APPROVED MINUTES OF THE MEETING

November 6, 2008

November 6, 2008	Project:	Madison Valley Storm Water Improvements
	Phase:	Schematic Design
	Last Review:	September 18, 2008
	Presenters:	Brent Middleswart, SPU Peter Nelson, Karen Kiest Landscape Architects
	Attendees:	Peter Triandafilou, Greater Madison Valley Community Council Celia Kennedy, SPU Grace Manzano, SPU Ruri Yampolsky, Office of Arts and Cultural Affairs

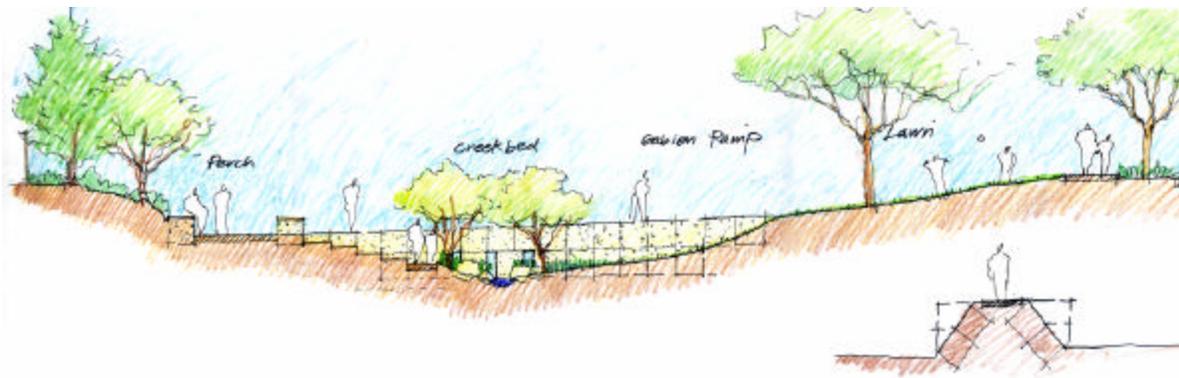
To unify the site, material simplification is being considered. Gabions create a trestle-like trail. A low vegetated hedge would soften the trail experience, while maintaining views across the site.

Is the gabion bridge intended to address ADA slope issues? Does it divide the site in half?

The gabions are an interesting idea; perhaps they could be more playful.

Are gabions safe for children to play on?

The five foot gabion height may be a concern; three-and-a-half to four feet may be preferable.

Yes, it is a response to ADA constraints. It is also an opportunity to create a bridge and dramatic topographic interest.

They are stable.
